Statement

We, Quectel Wireless Solutions Co., Ltd., declare on our sole responsibility for the product of RG620T-NA CS1 (FCC ID: XMR2023RG620TNA) & RG620T-NA CS2 (FCC ID: XMR2024RG620TNA) as below:

2.RG620T-NA CS2 removes B(n)71 RX filter, and adds B(n)71 duplex filter and related main components compared with RG620T-NA CS1, as shown below.

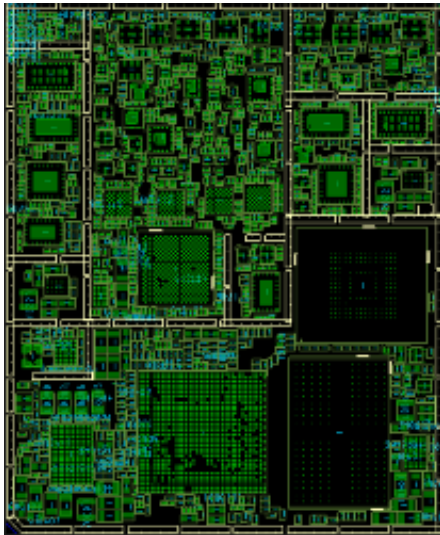
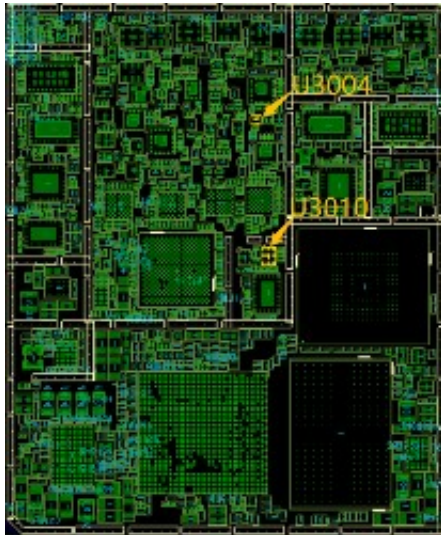
- PCB Layout changes: No
- Antenna change: No
- PA change: NO
- Adding or reducing materials: Yes(RG620T-NA CS2 removes B(n)71 RX filter, and adds B(n)71 duplex filter and related main components compared with RG620T-NA CS1.)

Parameter	RG620T-NA CS1	RG620T-NA CS2
Component Placement		
U3010	NM	IC RF DPX LTE/5G UNBalance B71 1.8×1.4mm H0.475mm RO
U3004	IC RF Rx filter UNBalance B71 15dBm 1.1×0.9mm H0.5mm RO	NM
